Engineering Peer Review of Coal Byproduct Disposal Plans

Kingston Fossil Plant

GeoSyntec Consultants

Bottom Ash Drainage Layers

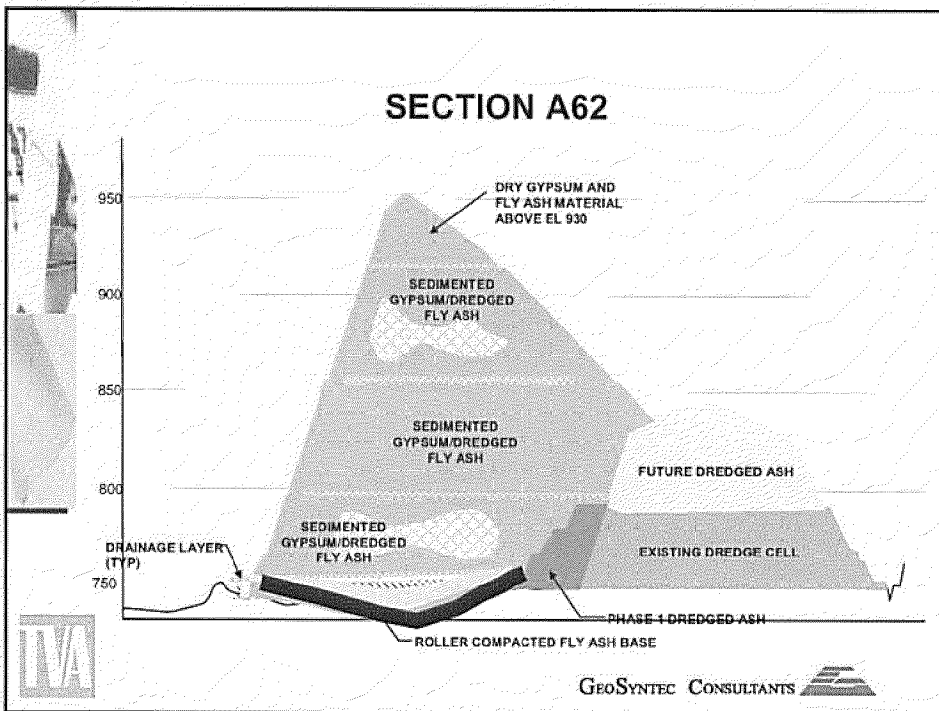
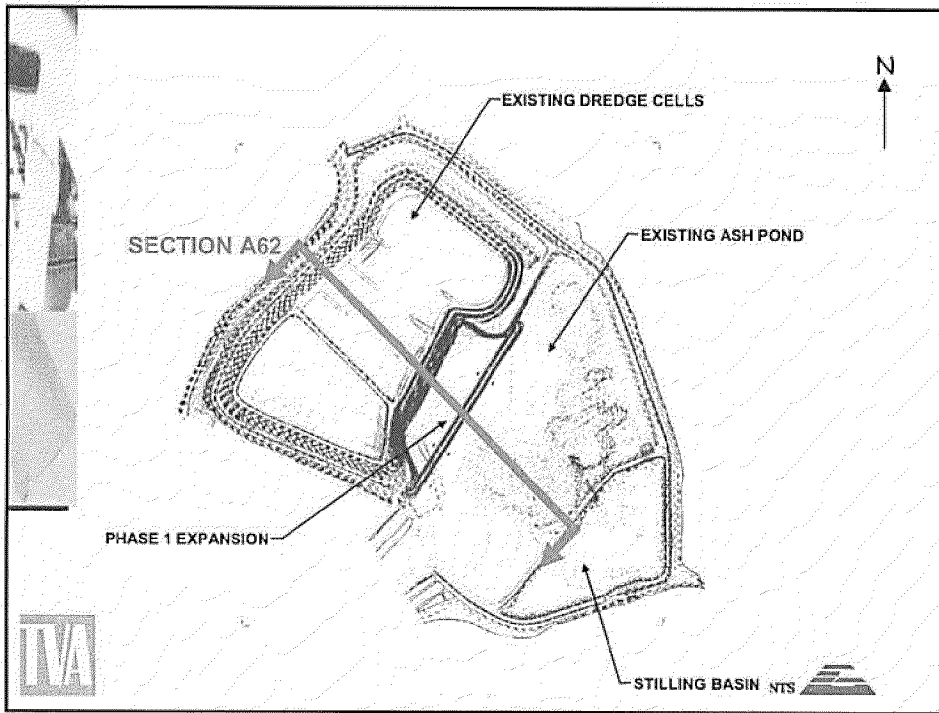
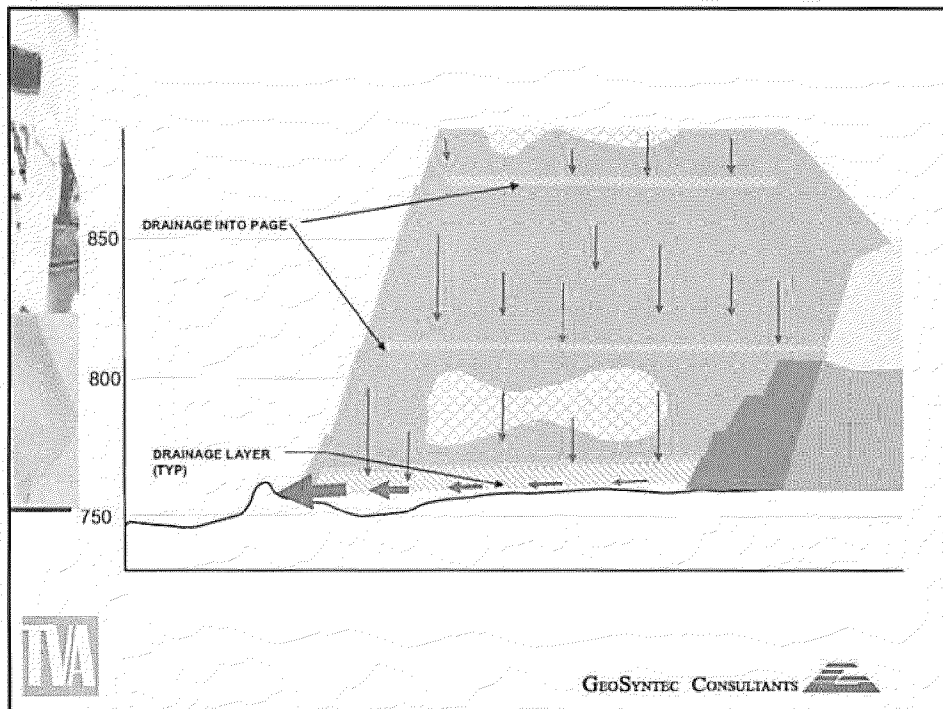
- Bottom ash drainage layers are proposed to be installed at the base of proposed gypsum stack, and at the elevations 810 ft, 870 ft, and 930 ft.
- GeoSyntec concurs that internal drainage and seepage control measures will help to improve stability.
- The drainage layers within the stack are introduced in Section 3.6 of Operations Manual to "...collect and channel drainage from within the stack". However, no calculations are provided to support this design premise
- Drainage control at the base of the stack will enhance the hydraulic separation of the overlying material from the underlying material and can reduce the head on the underlying compacted fly ash.

- GeoSyntec's comments on Section 3.6 includes "...recommend that leachate management practices be implemented"
 - Increase slope
 - Confirm hydraulic transmissivity and conveyance
 - Reduce potential for ponding
- Design calculations for the drainage layer were not provided and are needed
- Need calculations to demonstrate that the impact of settlement is addressed and that the overall hydraulic capacity of the drainage layer is sufficient for the design flows

- ~~f.~~ Revisit Upper Blanket Drainage Layers
 - g. Resolve Differing Stratification between Models
 - 2. In conclusion to ensure the stability of the design we will share Parson's calculations with GeoSyntec to get total by-in that the stack is stable.

13. Seepage Analyses (cont.)

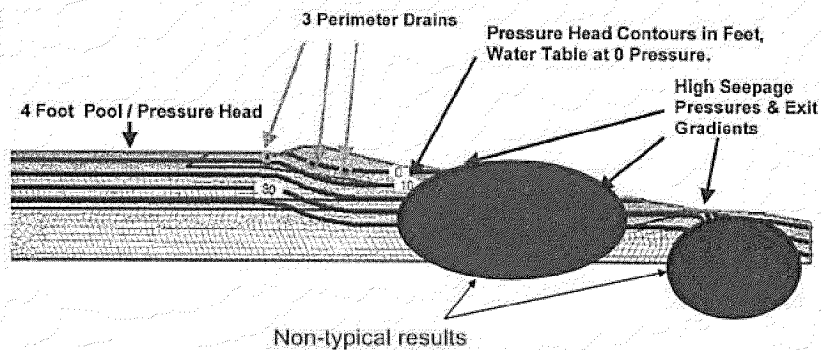
- Construction of critical section appears reasonable
- Hydraulic conductivity values used in model appear extremely high:
 - derived from CPT data that utilized Soil Behavior Type Classifications (SBT) for typical soils
 - resulting values are not consistent with in-situ tests performed in vicinity of "blowout"
 - selected parameters consistent with gravel and/or coarse sand

- Graphical output
 - Peculiar results that are not typical of conventional seepage analyses
 - no change (or non-typical change) in slope of pressure head contours as they pass through different strata
 - pressure head contours exit slope
 - non-typical flow-line regimes
 - Authors concur with the recommended use of slope drains and geonet composite drains, but no details are provided regarding the depths of the drains used in the model
 - Surficial drains can help control water near the surface of the slope, but do little to dissipate high subsurface water pressures (if they exist)

- Address specific issues identified
- Review input data, specifically hydraulic conductivity values
- Construct independent model using conventional seepage model (e.g., SEEP/W, SLIDE)
- Run simulations and calibrate to known conditions
- Run series of simulations for different drain configurations
- Incorporate calculated pore water pressures into dike stability evaluations

1. The level of the detail presented in the permit application was conceptual. Both consultants agree with the approach for correcting the seepage failure. Differences in the methodology were expressed by GeoSyntec. To insure consensus between TVA Hydrologists, Parsons, and GeoSyntec on model inputs and boundaries:
 - a. Both consultants are to be tasked with analyzing the French Drain (using differing methods)
 - b. Reconcile differences (if any) in model results and impacts to design
 - c. Utilize the results of these analyses as the basis for the detailed to insure the optimum fix is designed.
2. The results of these analyses will be used as the basis for the detail design to be submitted to TDEC as part of the Minor Modification

Option 1 (report Fig. 2)

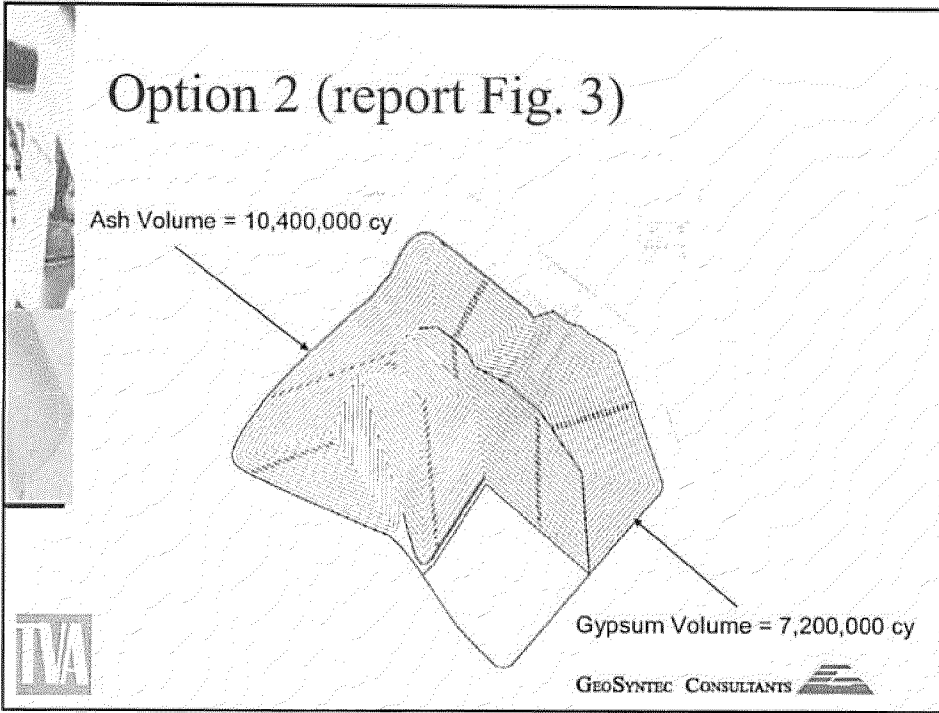
- Option 1 (report Figure 2):
 - Maintains 25-acre ash pond within northwest portion of existing ash pond
 - Provides approximately 3,000,000 cy of gypsum (allows 9 years of disposal before making decision on ash pond)
- Option 2 (report Figure 3)
 - Also maintains 25-acre ash pond but limits gypsum disposal to the northeastern portion of the existing pond
 - Provides approximately 7,400,000 cy of gypsum (allows 22 years of disposal before making decision on ash pond and provides 5 additional years of capacity compared to current plan)
- Both plans result in increased life when the ash ponds are decommissioned and dry ash disposal commences
